AGENDA Molalla Planning Commission 6:30 PM, November 2, 2022

SDR02-2022 and CUP04-2022 - Fast food w/drivethrough

Date: October 26, 2022 for the November 2, 2022 Planning Commission Meeting

TENTAIVE SITE AND UTILITY PLAN

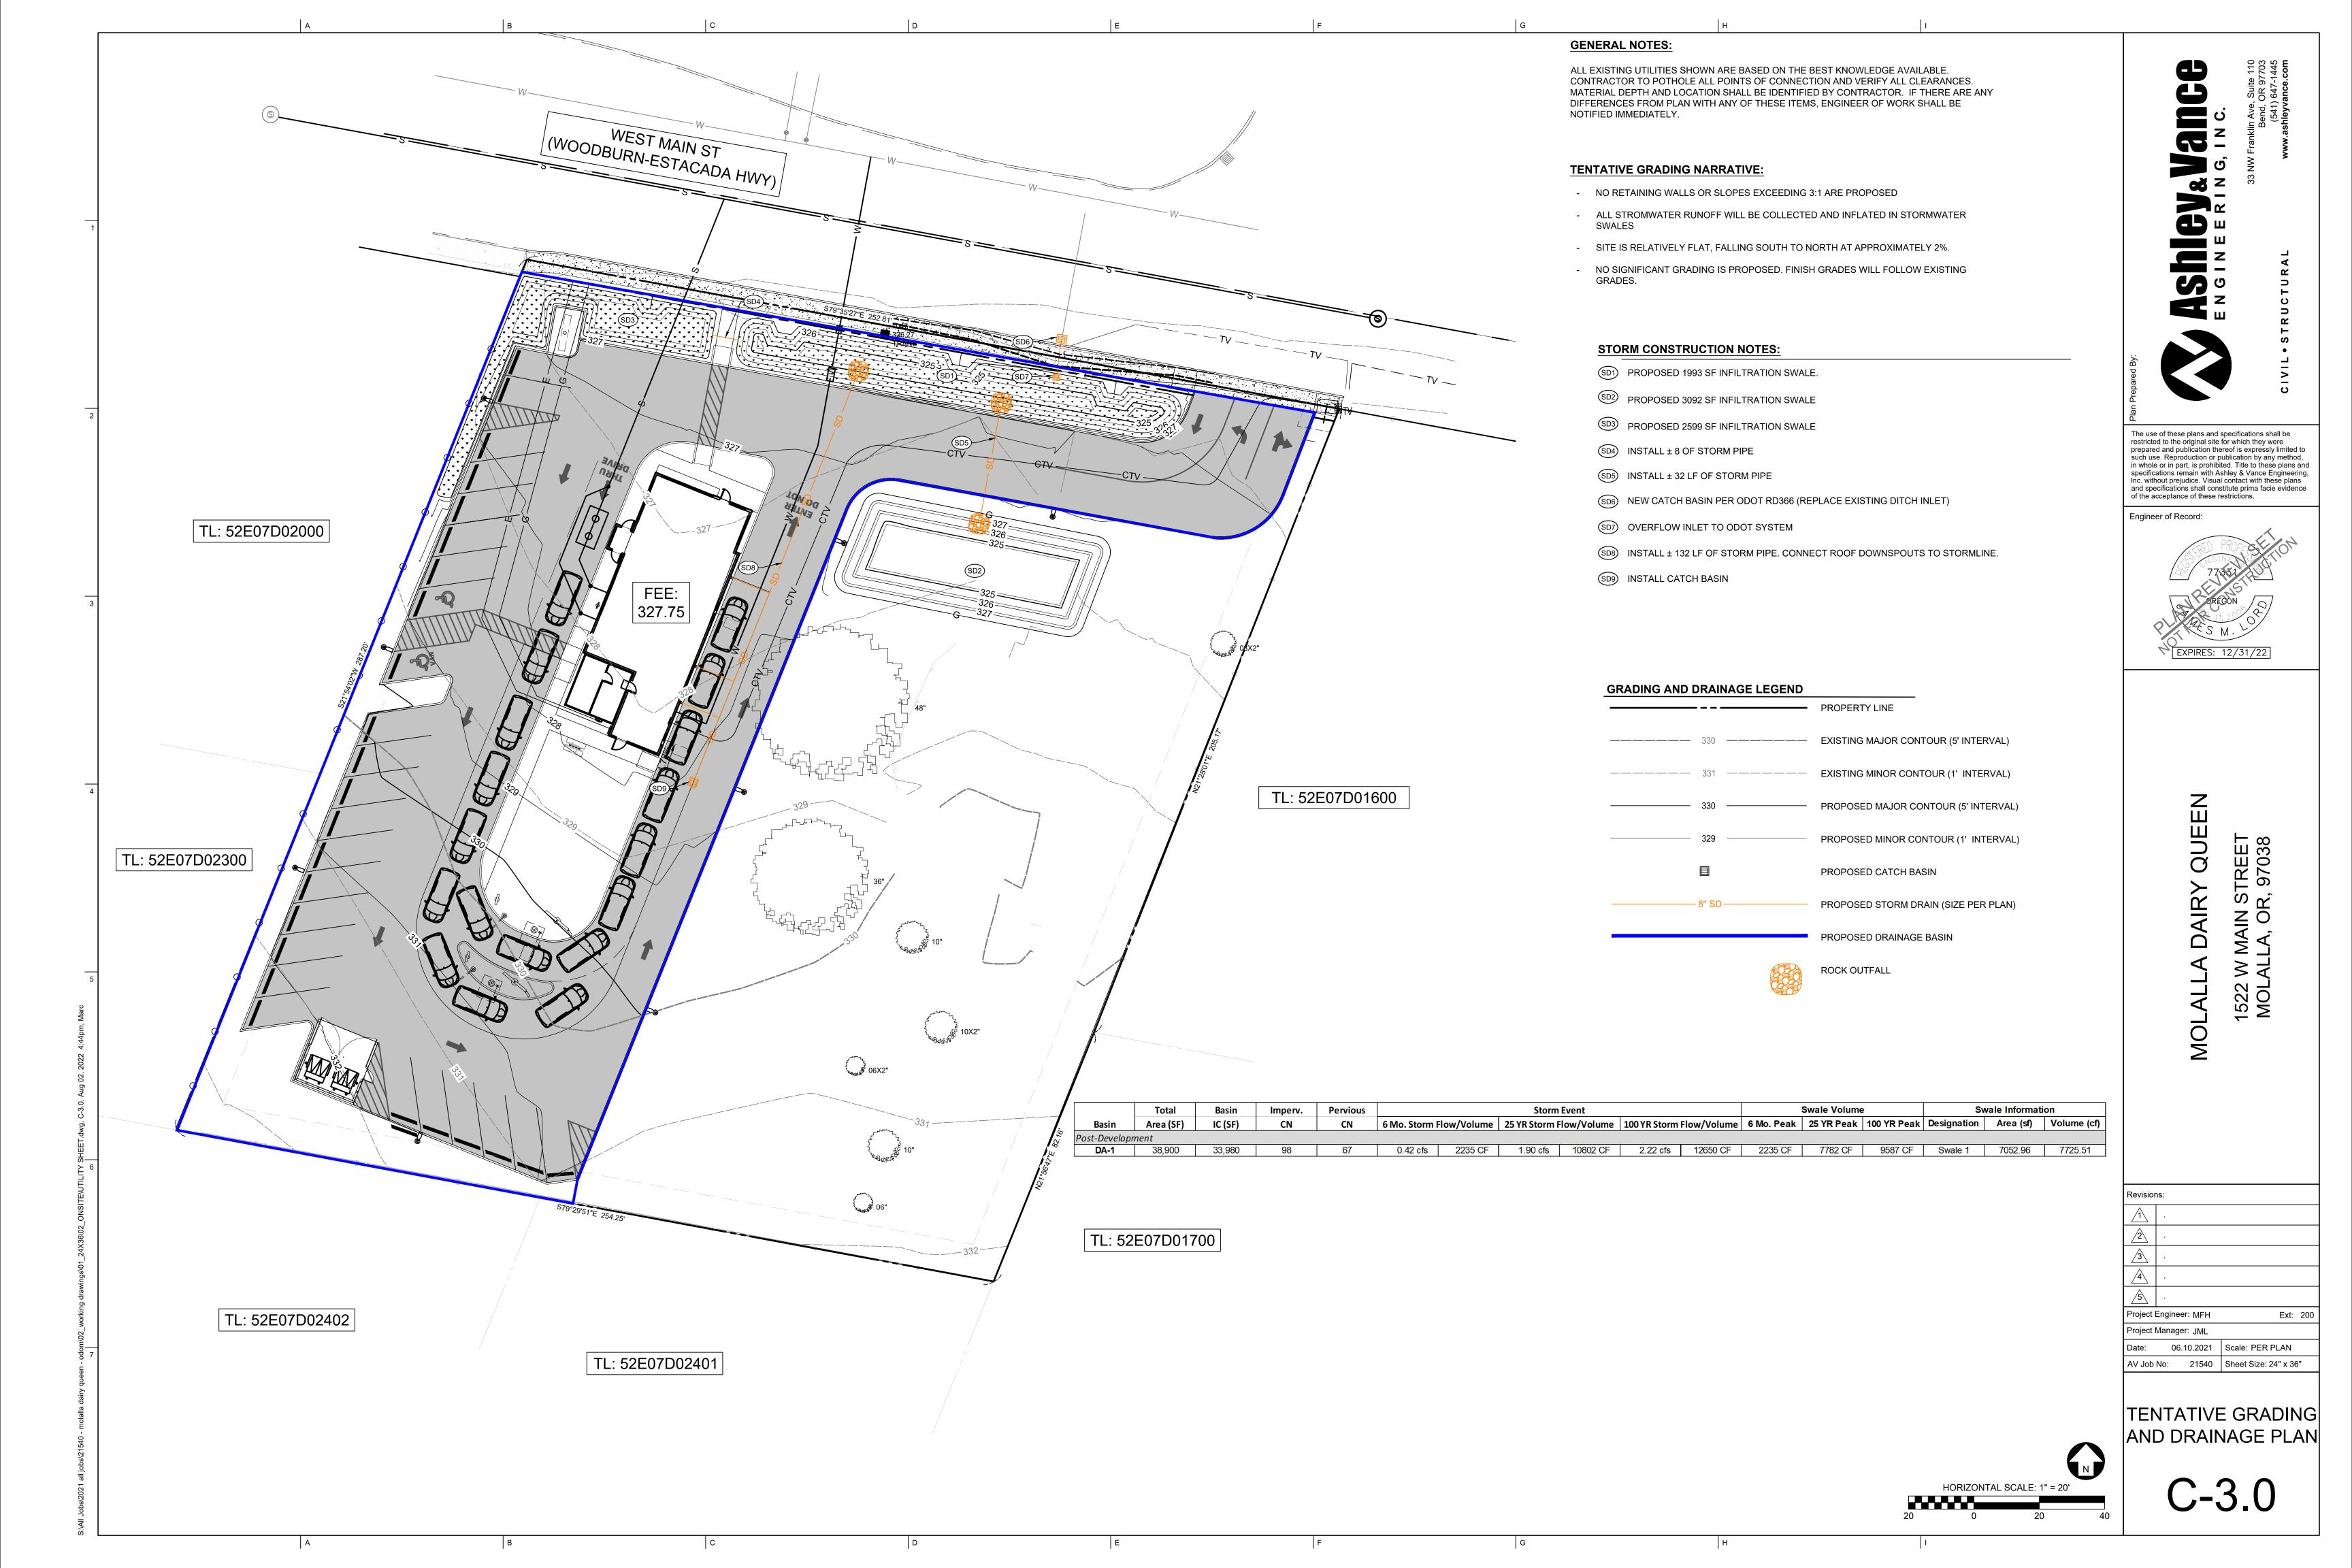
- d. The site plan shows 25 parking spaces. Submit a revised site plan that shows 20 spaces with remaining space for landscaping. Alternatively, show 2 additional spaces for EV charging stations for a total of 22 spaces. In addition, the parking spaces adjacent to the trash enclosure may create a conflict with backing movements and shall be reviewed as candidates for removal and/or redesign.

- f. Applicant shall confirm all parking stall and drive aisle length and width dimensions are met on site plans submitted for building permit authorization

The Applicant's site plan shows a pedestrian crossing within the west entrance of the drive aisle of the queue lane. The Applicant's narrative does not state the materials or design of the pedestrian walkway. See condition of approval 2c.
